Change Order 7

Date of Issuance: <u>August 29, 2019</u>	Effective Date: <u>August 29, 2019</u>
Owner: <u>City of Fort Bragg</u>	Owner's Contract No.: <u>2018-01</u>
Contractor: <u>Wahlund Construction Inc.</u>	Contractor's Project No.: _____
Engineer: <u>HDR</u>	Engineer's Project No.: <u>260093</u>
Project: <u>WWTP Upgrade Project</u>	Contract Name: _____

Project: Wastewater Treatment Plant Upgrades

Job Title: Core Drill Diffuser Section

FBMID Ocean Outfall - Diffuser Section Cleaning Concept

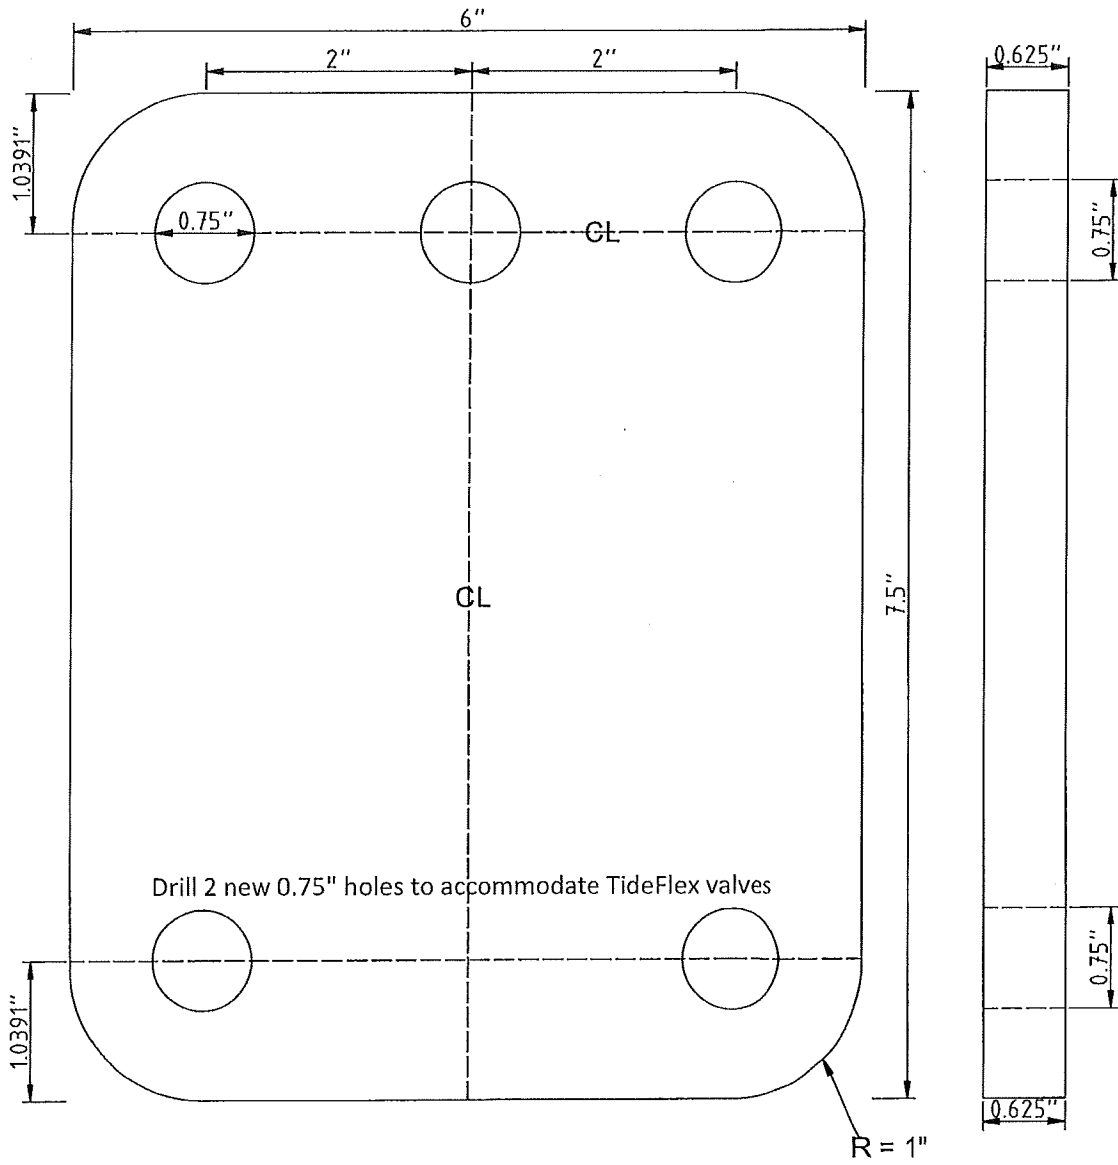
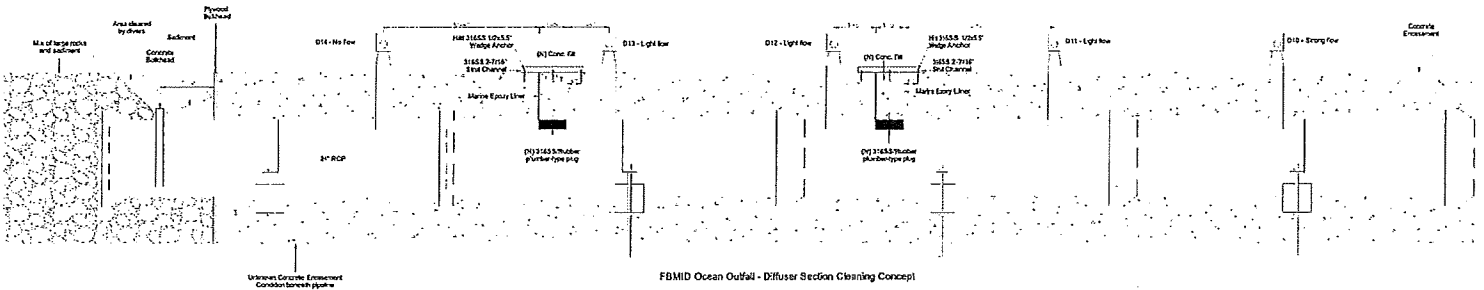
Task 1: URI will mobilize a three-person dive crew along with shallow air equipment and a dive utility vessel to the Fort Bragg Municipal Utilities District Outfall. The crew will core drill 12-inch holes through the concrete encasement and the top of the pipe according to plans developed by the District and URI (sample attached). The crew will then use pumps and other means to clean the diffuser section between port 10 and the end gate through the core drilled holes. Material will be diffused and sidecast. Once the diffuser section is cleaned, the holes will be reinforced with marine epoxy, plugged at the crown of the pipe with a 316SS rubber plumber type plug, filled with concrete, then restrained with a 316SS strut channel.

Task 2: URI will remove all existing (14) flap valves from the outfall diffuser section. Once the flaps are removed, the divers will drill two (2) new holes in the aluminum bronze plates according to the attached drawing and install new TideFlex valves using 316 SS nuts, bolts and washers. New TideFlex valves are to be purchased by URI at cost + 15%.
